**From:** Turchy, Michael A  
**Sent:** Monday, July 7, 2025 10:05 AM  
**To:** Annino, Amy; Jamison, John  
**Cc:** Amschler, Crystal C CIV USARMY CESAW (US); McHenry, David G; Wojski, Paul A; Pjetraj, Michael; Bukowy (HNTB), Kat A  
**Subject:** RE: Request for Additional Information: DWR 20250109 V3 - Hurricane Helene I-40 Pigeon River Gorge Emergency Relief Project

**Subject:** Request for Additional Information: DWR 20250109 V3 - Hurricane Helene I-40 Pigeon River Gorge Emergency Relief Project

# TIP PROJECT: I-40 PIGEON RIVER

**S-006R3: REVISED PERMIT DRAWINGS**  
**DATE: 06/03/2025**

REVISED 5/28/2025

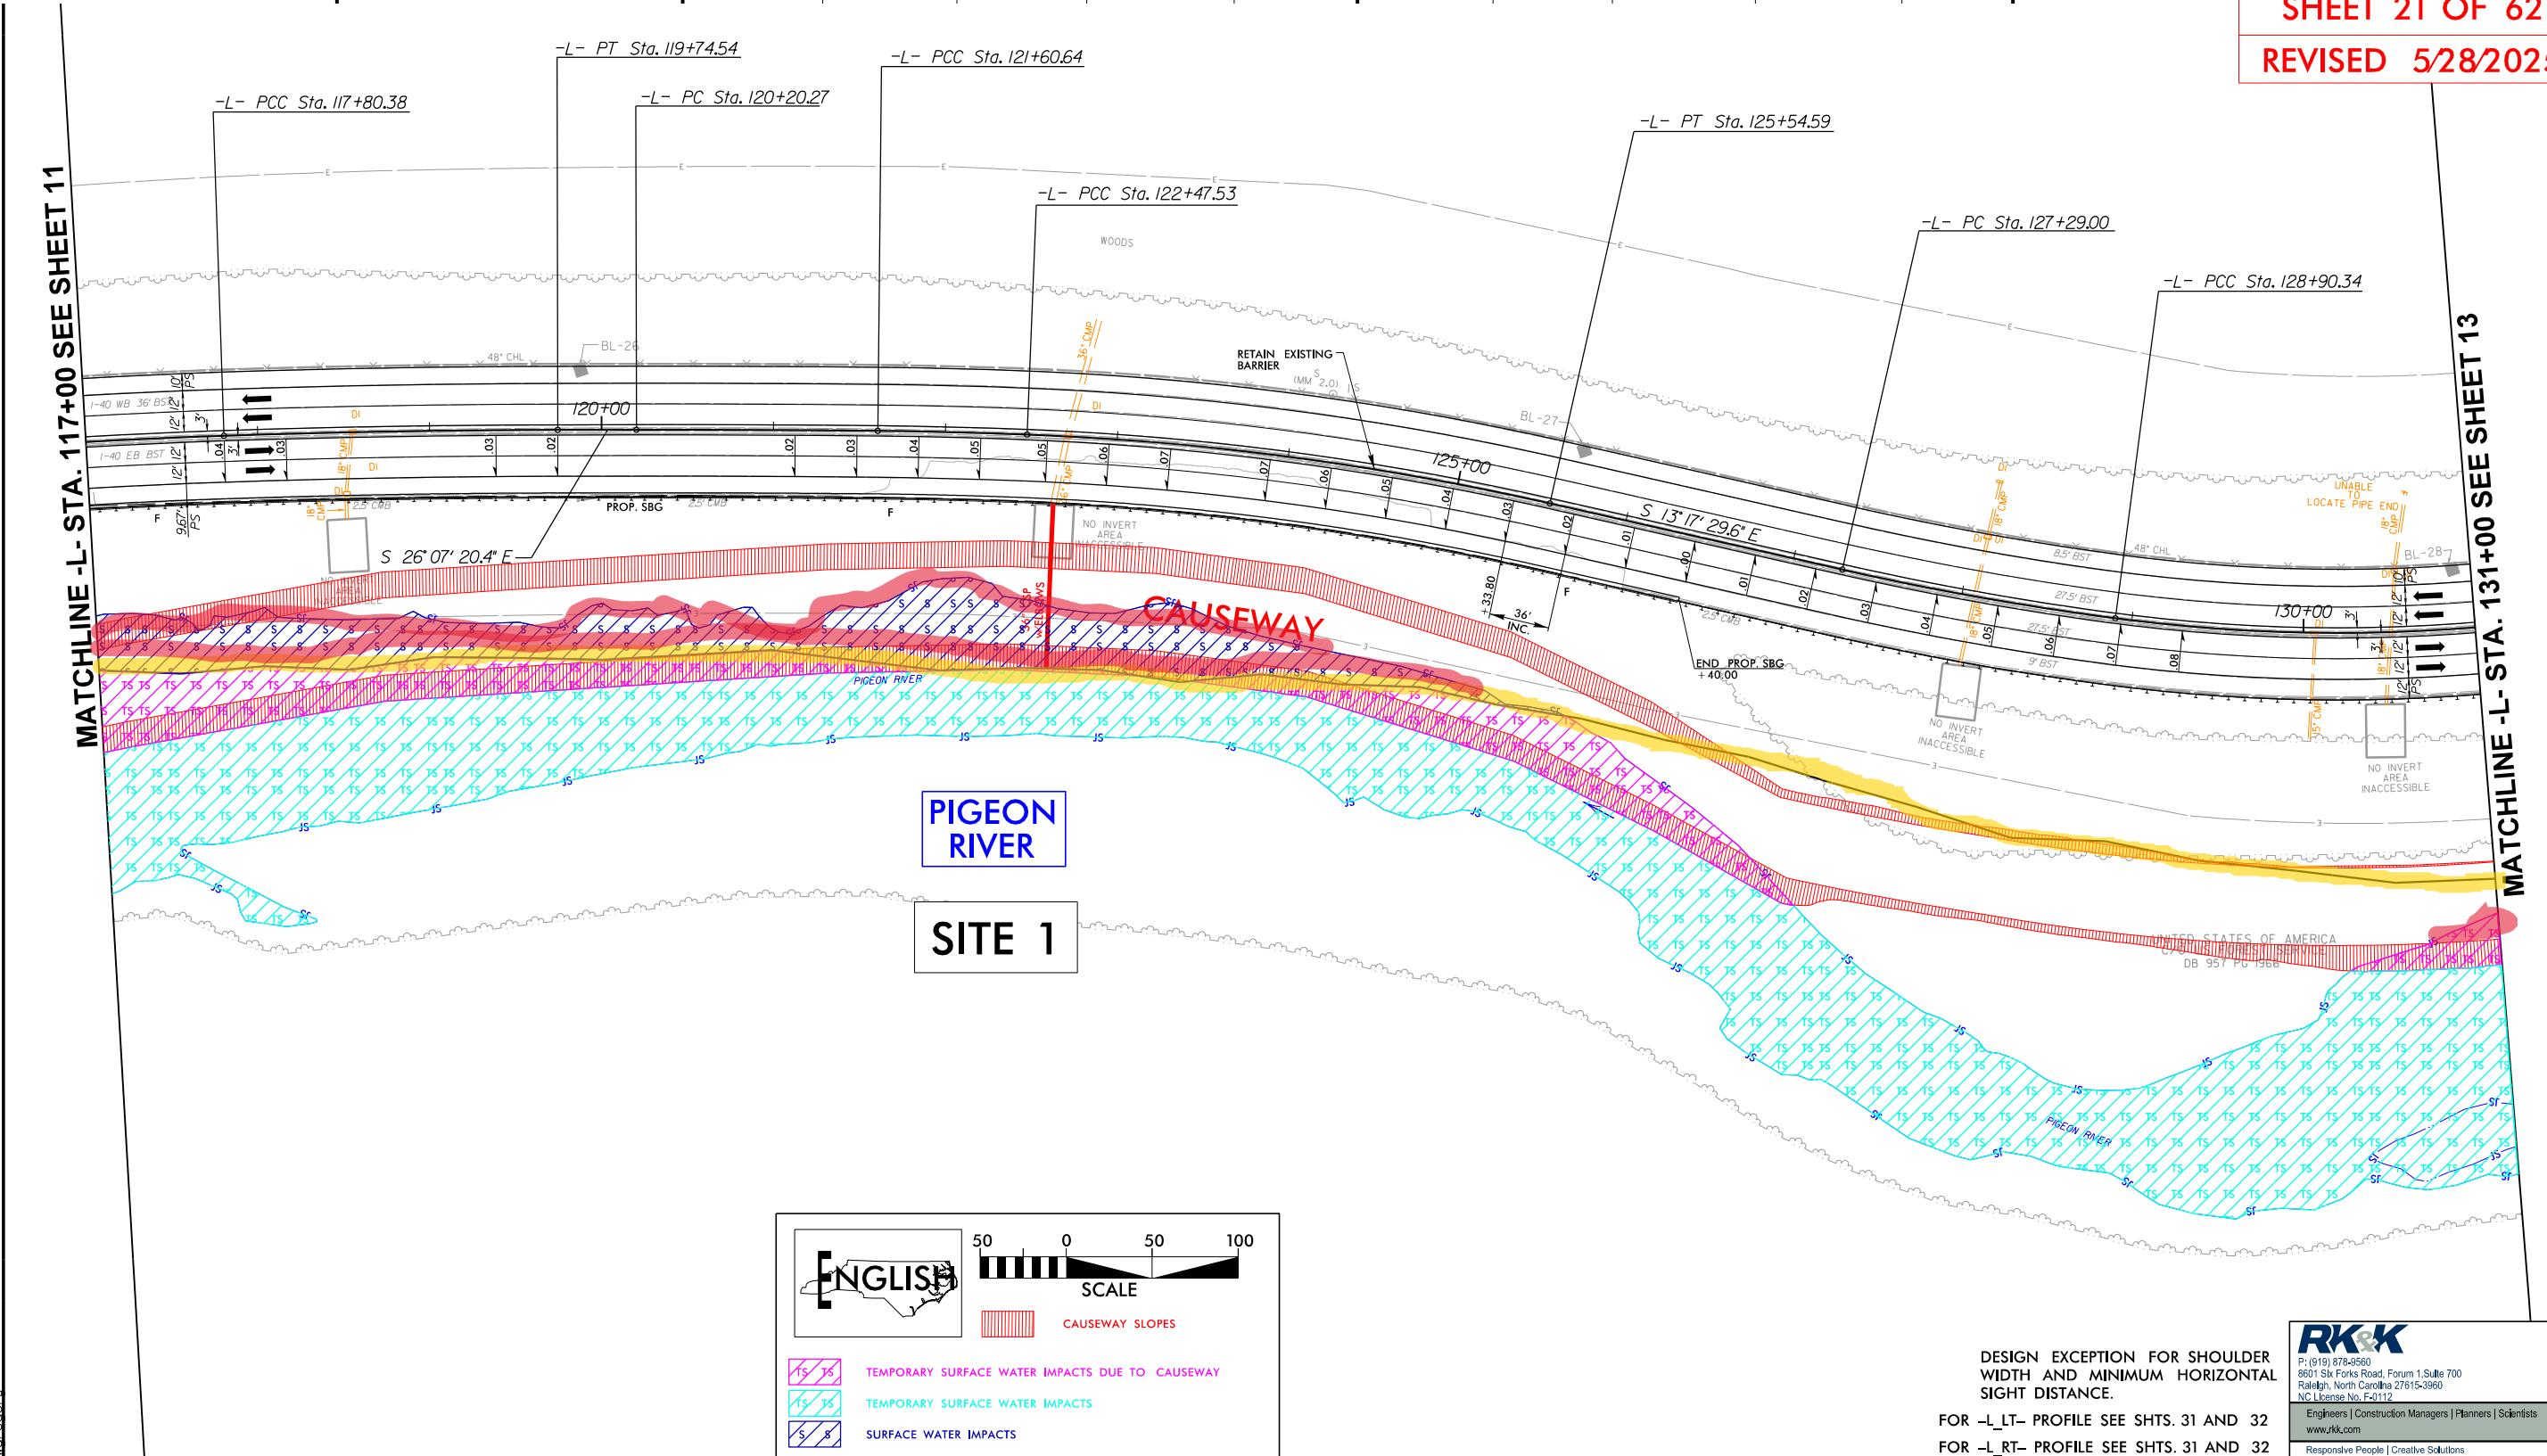
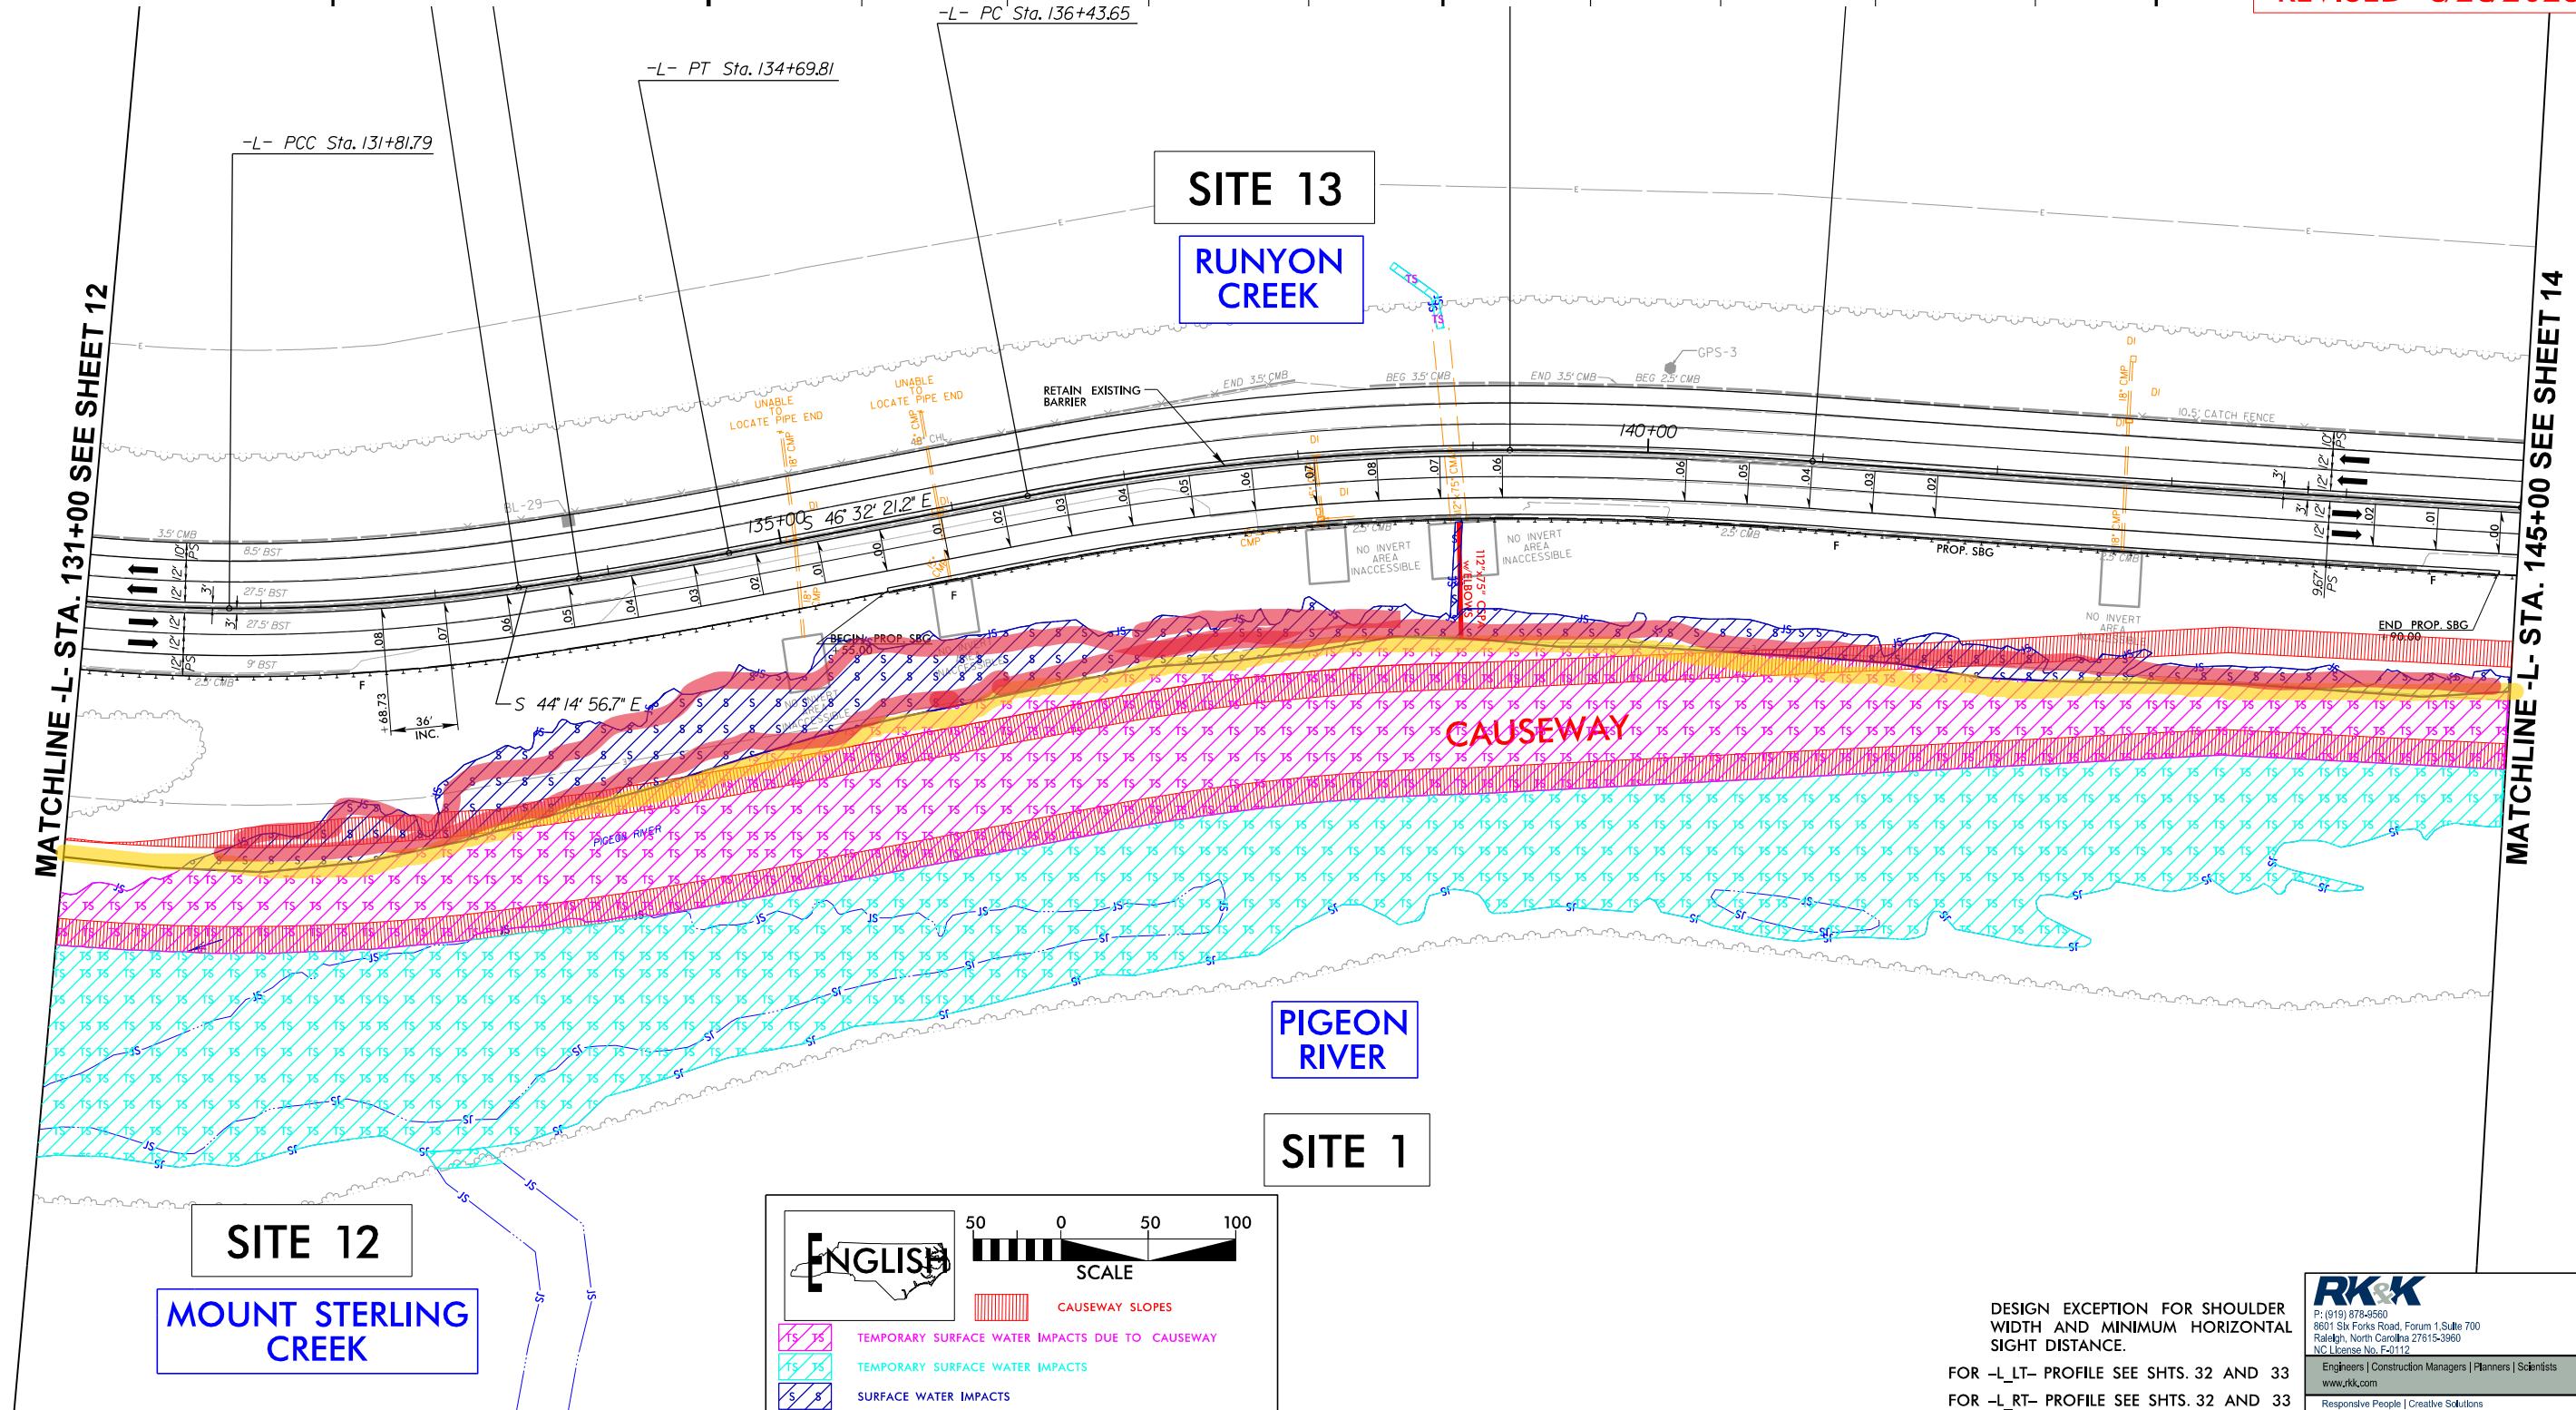
3. Please show the footprint of the proposed retaining wall through the project area

The proposed wall is located on the submitted set of drawings, and attached is a marked up set of drawings highlighting the wall for clarity, titled “**Drawings with Wall Highlighted**.”

The wall is highlighted in yellow. Wall impacts are highlighted in red.

Additionally, the impact summary table has been excerpted on each page to clarify the quantify the wall impact.

As previously noted, impacts are shown using the “scour zone limits” of the Pigeon River, as locating the ordinary high water mark post-Helene is not possible. Therefore, these drawings display a “worst case scenario” and are likely much lower than indicated.

The total proposed wall impacts to the Pigeon River are 12,116 linear feet.
